From: [REDACTED]
Sent: 31 December 2019 11:57
To: Planning.Responses <Planning.Responses@arun.gov.uk>
Subject: BN/122/19/EIS: -Land North of Barnham Road, Eastergate.

Your ref
BN/122/19/EIS

Proposal: Scoping opinion.

Site: BN/122/19/EIS: -Land North of Barnham Road, Eastergate.

O.S. REF: SU9505NW

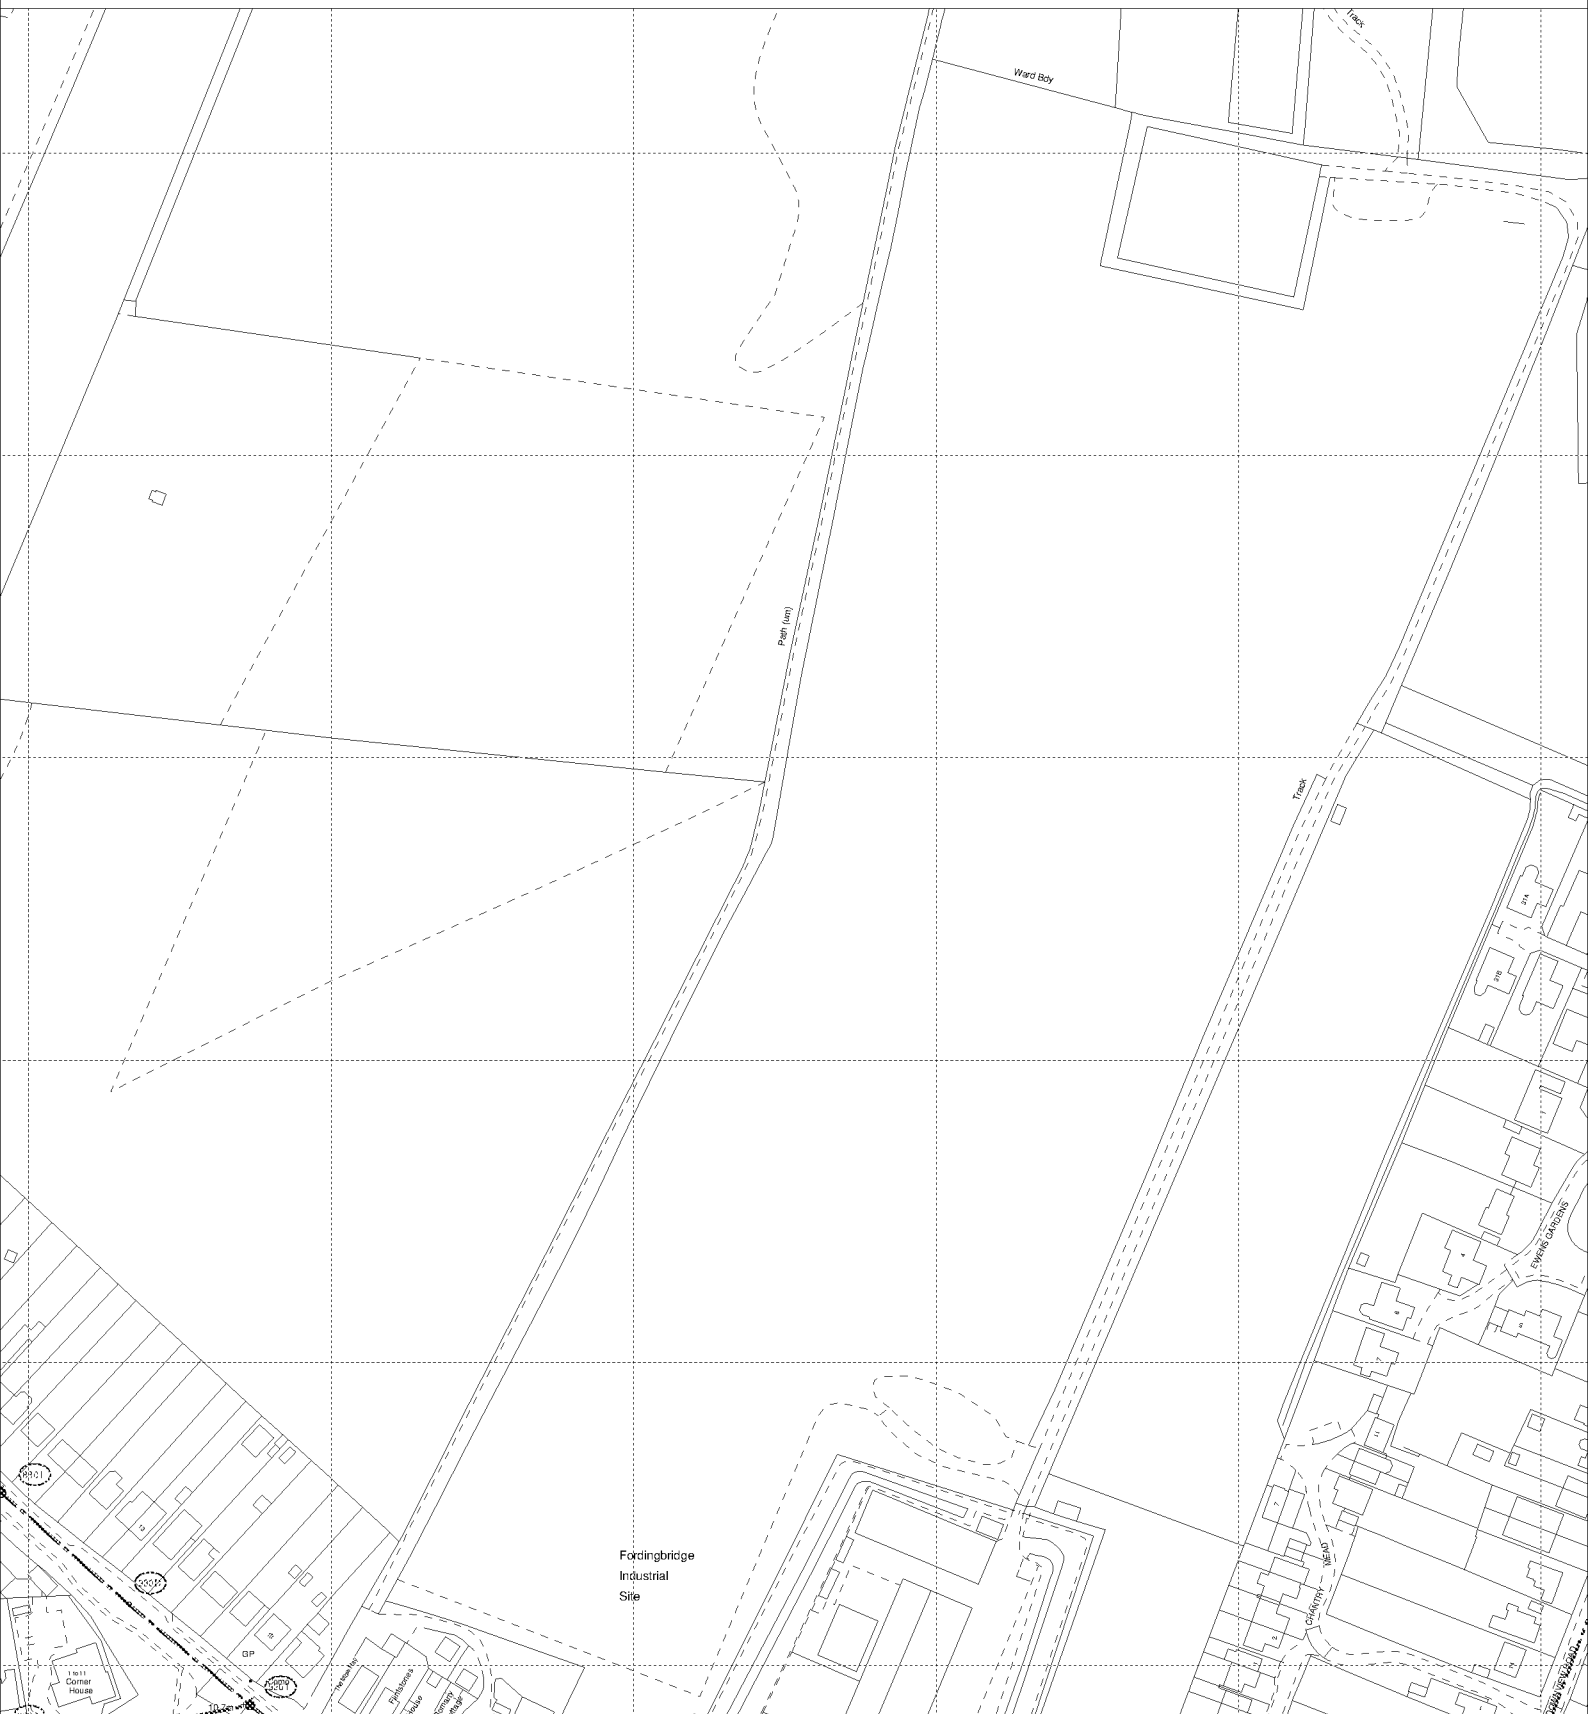
- Due to the size of the development and to protect the premises from the impact of sewage flooding, an assessment is required to ascertain an appropriate point of connection to the foul sewerage network.
- Southern Water requires a formal application for a connection to the public foul sewer to be made by the applicant or developer.
- There are no public surface water sewers located within the vicinity of the site and alternative methods of disposing of the surface water should be investigated i.e. soakaway, ditches or local water courses.
- It is possible that a sewer now deemed to be public could be crossing the development site. Therefore, should any sewer be found during construction works, an investigation of the sewer will be required to ascertain its ownership before any further works commence on site.
- Southern Water does not supply water to this area.
